**FERRARI NORTH AMERICA, INC.
TECHNICAL SERVICE DEPARTMENT**

TECHNICAL INFORMATION

Area	Model	Bulletin n°	Date	Pages
4	<i>Challenger Stradale</i>	1210	June 2004	1

SUBJECT: Retaining clip for brake pads

Fig. 1 shows the difference between the clips. The new clip is mounted on the calliper while the old version is shown next to it on the right.

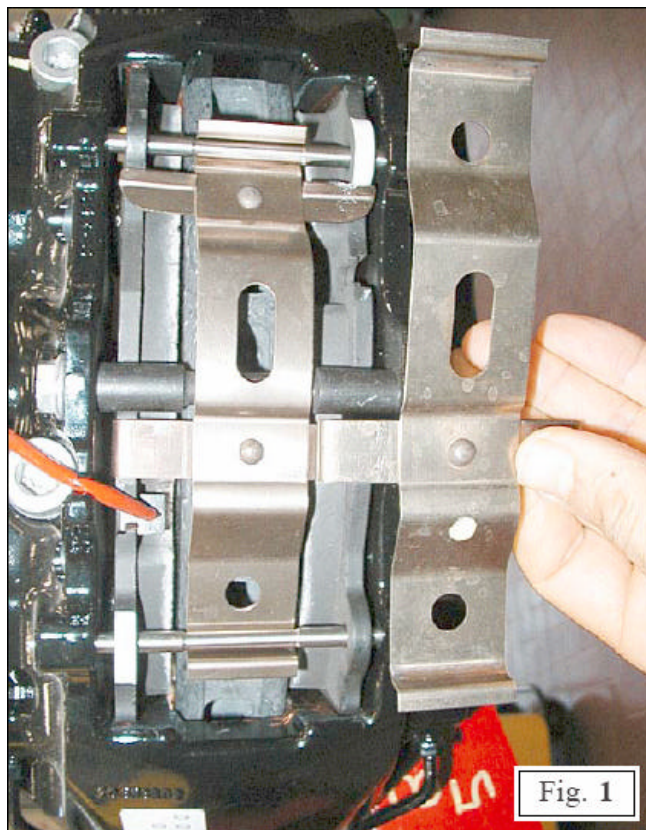
This bulletin is to inform you that the brake pad retaining clips shown below have been modified in order to help improve the noise dampening characteristics on the pads inside the brake callipers.

The new clip is part of the **“Complete Front Pads with Spring”** kit, **Part No. 70000976** and was introduced into production as of **Assembly No. 50894**. Our Parts Department will only supply the kits provided with the new retaining clips for the brake pads.

Fig. 3

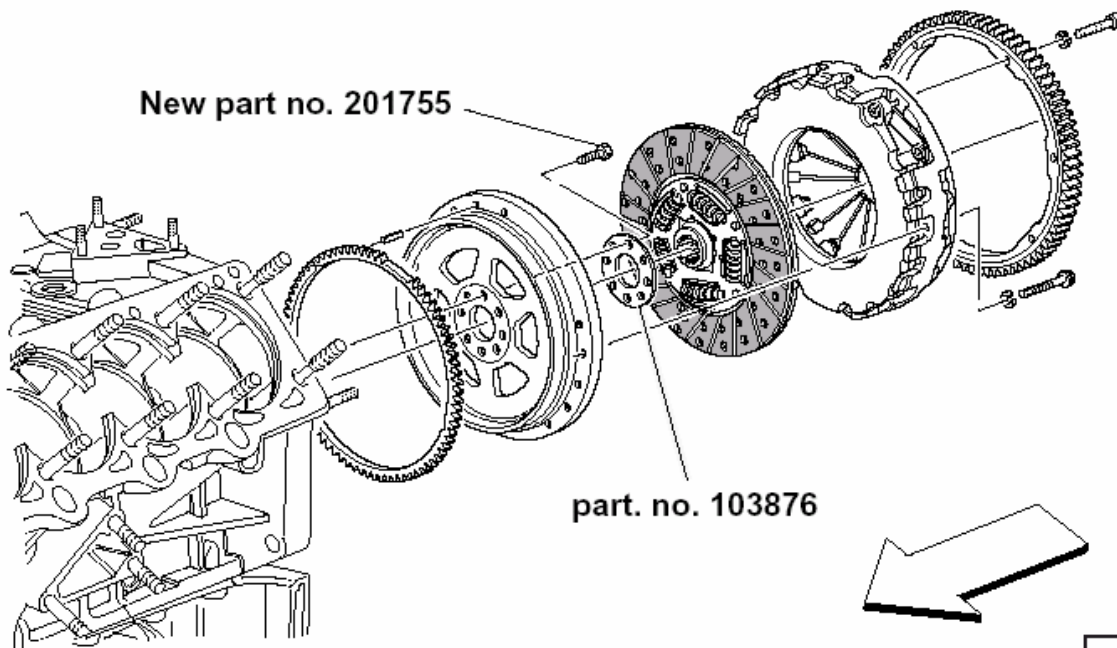
They should be installed along with a new washer (part number;103876) anytime the flywheel or the clutch is being replaced. (Fig.3)

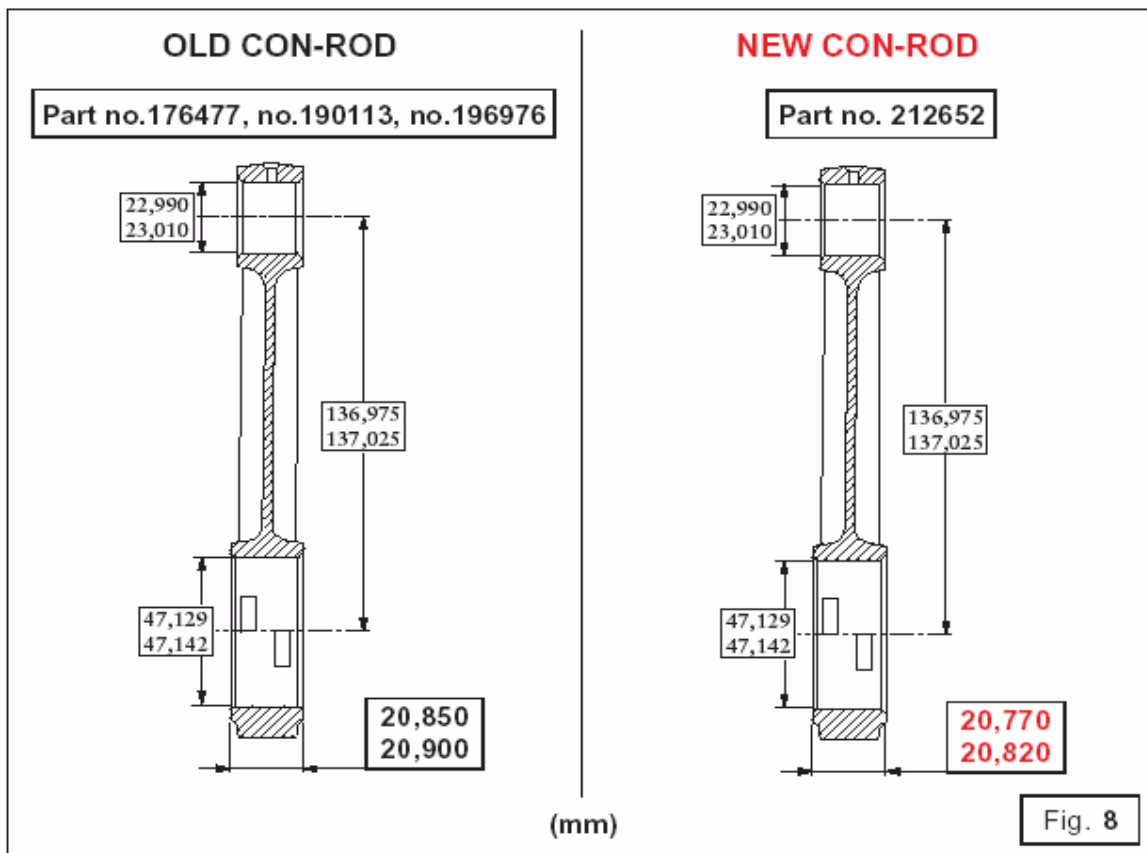
This measurement has been reduced with the use of the new con-rods part no. 212652, as shown in Fig. 8.

- › If any signs of wear **are found** on the contact surfaces that indicate the con-rods must be replaced, **even on just one pair of con-rods, all the con-rods must be replaced using the newer version with molybdenum layer.**
- › The new con-rods supplied will be identified as “Pankl con-rod kit” (8 pieces), part no. 70001114.
- › As a result of the new, specific technical features, it will be possible to replace the individual con-rods only on vehicle versions that already have the newer style con-rods fitted. New and old versions cannot be used together.
- › If individual replacement of the newer style con-rods is necessary, you must order the new parts using the same class of weight of the parts being replaced, which is indicated with a letter engraved on the large ends and refers to the weights indicated in the table in Fig. 9.

SUBJECT: L H Hydraulic Tensioner

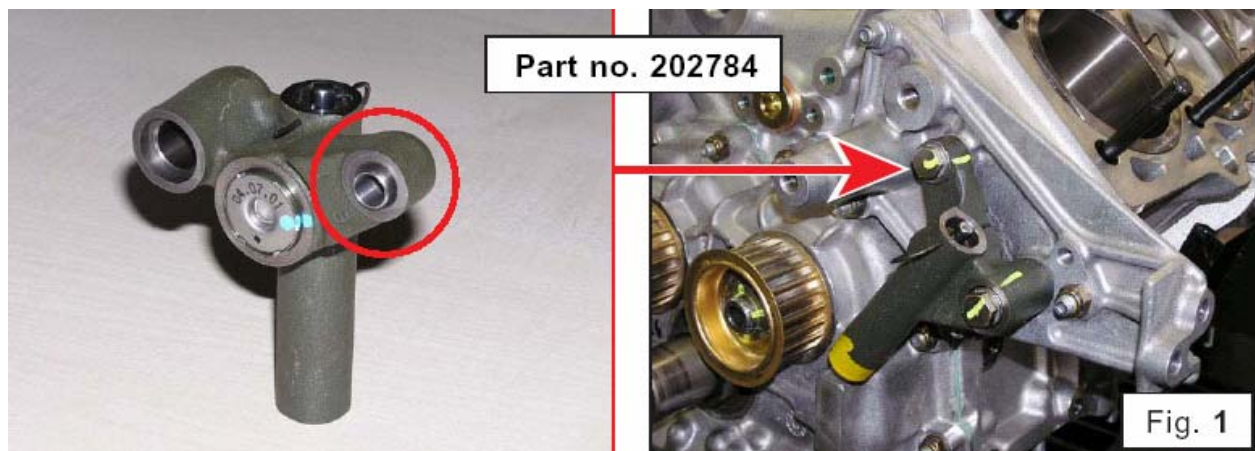
For your information, starting with chassis number 136507 (assembly number 54662, engine number 83762) a newer style belt tensioner with a centering bushing is being used. (Fig. 1)

“Hydraulic Steering Delivery Pipe from Pump to Rack”

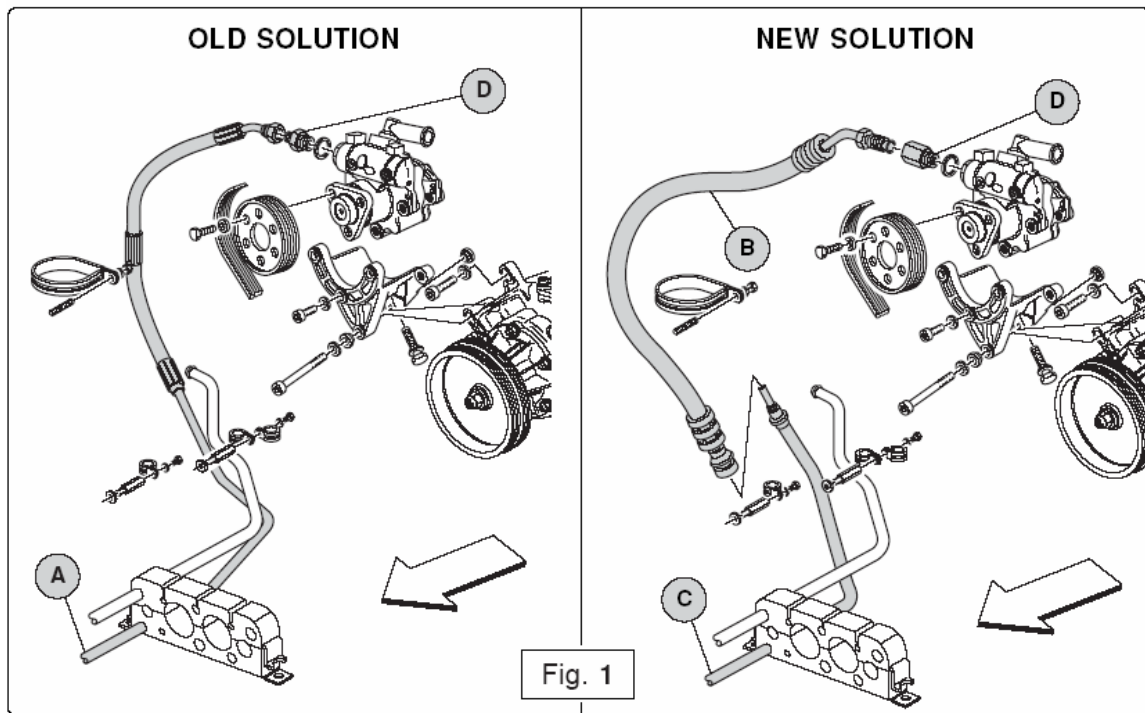
In addition to the pipe in question, the union (**D**), which has a female section housing the male section of the pipe (**B**), will also be replaced (Fig. 2).

“Hydraulic Steering Delivery Pipe from Pump to Rack”

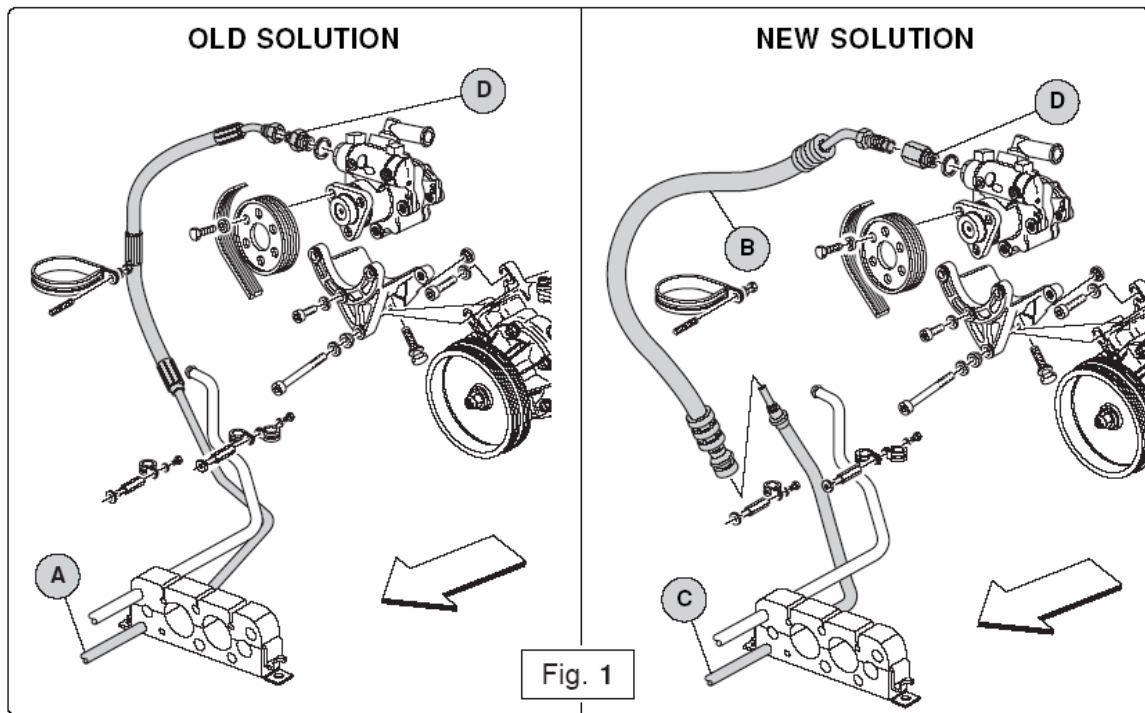
In addition to the pipe in question, the union (**D**), which has a female section housing the male section of the pipe (**B**), will also be replaced (Fig. 2).
